DATA SHEET FOR SITE DEVELOPMENT PLAN REVIEW

Plan Title:	S-24-11 Warehouse Building at 601 Garrison Oak Drive
Plan Type:	Site Development Plan
Location:	West side of Garrison Oak Drive, North of White Oak Road
Address:	601 Garrison Oak Drive
Tax Parcel:	LC-05-068.00-02-03.00-000
Owner:	Garrison Oaks, LLC
Site Area:	12.813 acres +/-
Zoning:	IPM-2 (Industrial Park Manufacturing Zone - Business and Technology Center) SWPOZ (Source Water Protection Overlay Zone: Tier 2 - Primary Wellhead Protection Area)
Current Use:	Vacant Lot with existing City of Dover Water Tower
Proposed Use:	Warehouse/Logistics Center
Parking:	Required: 125 Proposed: 87 including 4 handicapped (Waiver Included in Packet)
Water and Sewer:	City of Dover
Waiver Requests:	Partial Elimination of Upright Curbing Partial Reduction in Parking
For Consideration:	Performance Standards Review Application

Application Review Commentary

FILE #:	S-24-11
APPLICATION:	Warehouse Building at 601 Garrison Oak Drive
REVIEWING AGENCY:	City of Dover Planning Office
CONTACT PERSON:	Katherine Oehmke, Planner I
PHONE #:	(302) 736-7196
Email:	koehmke@dover.de.us

COVER SHEET
AND OVERALL
LAYOUT

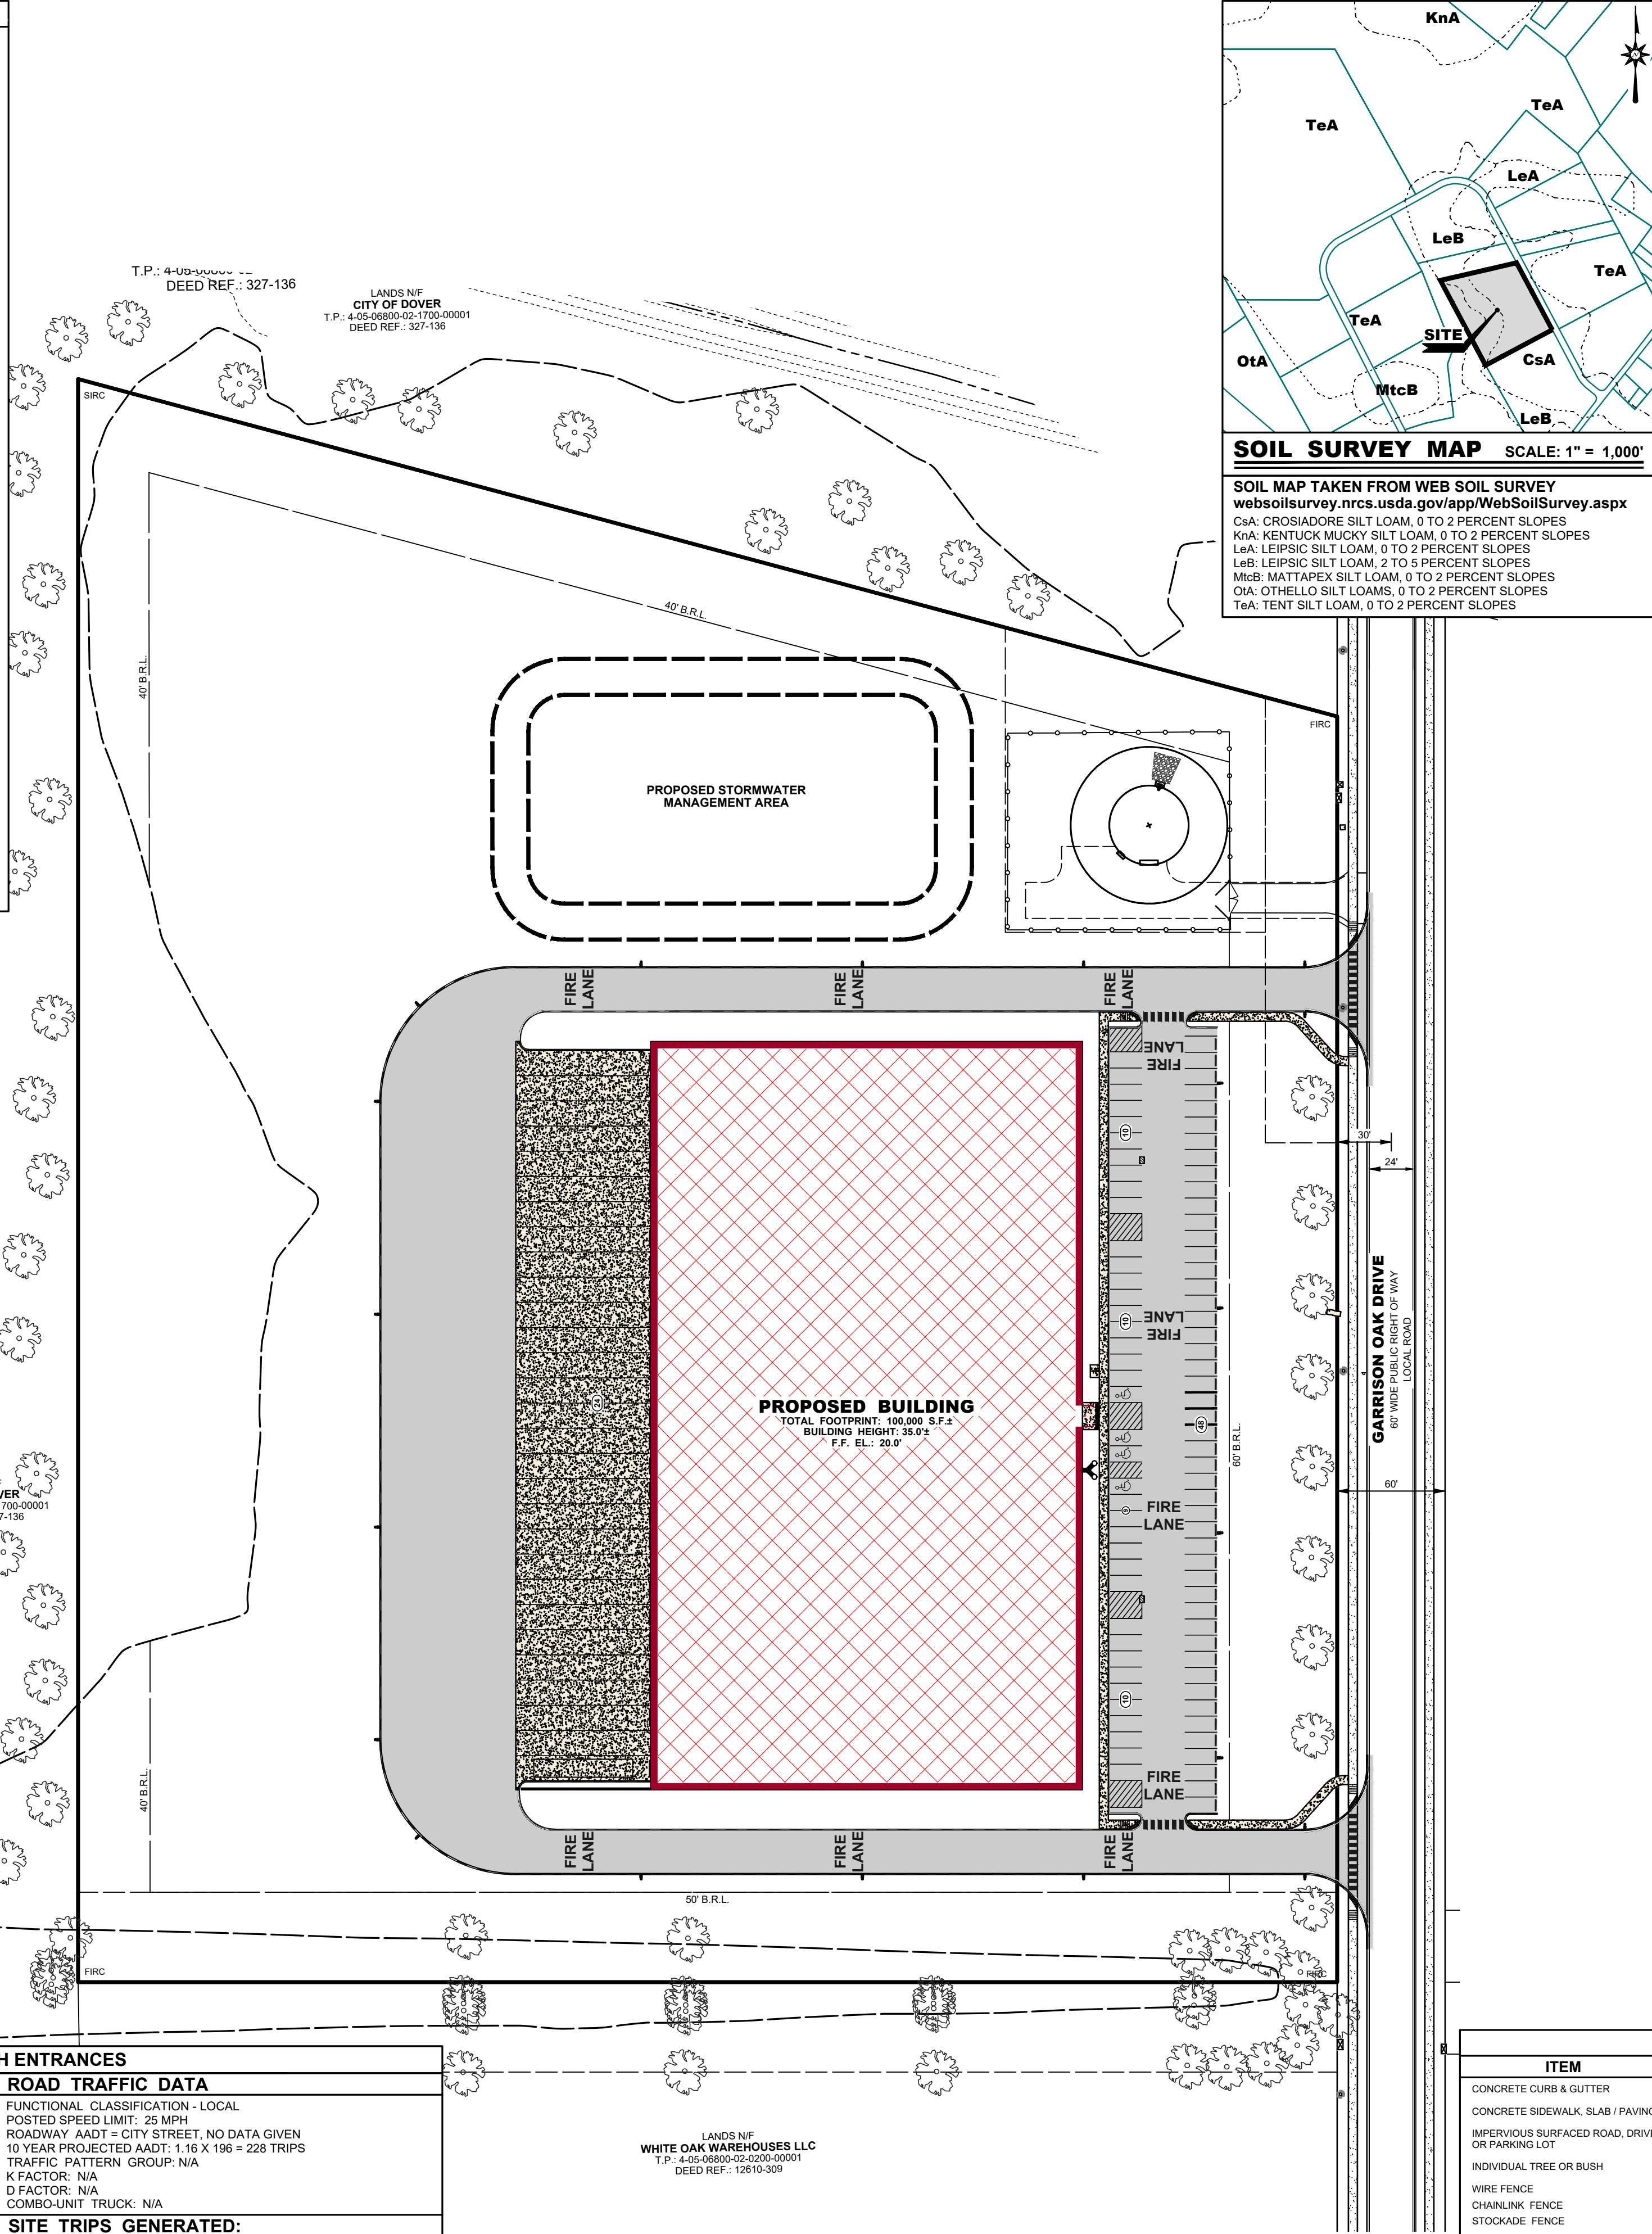
- a. Site Data #4 – Add SWPOZ to the Zoning.
 - b. Site Data #12 - You have drawn 28 loading berths but noted 24. Can you change the drawing lines or update the number?

- c. Please add the following to the data columns:
 - (a) Bicycle parking required and provided, please note on the cover page along with a detail of the bike rack to be installed.

- (b) Trash to be private (?).
 - (c) Please list the actual anticipated height of the structure.
 - d. Cover Page Note 17, change the description from “administration” building to warehouse building.

- e. Please add the FEMA Firm Panel number. I show it should be 10001C0186J and add date

(I show effective on 7/7/2014). Also please list LOMR (I show 17-03-0701 effective 6/4/2018).
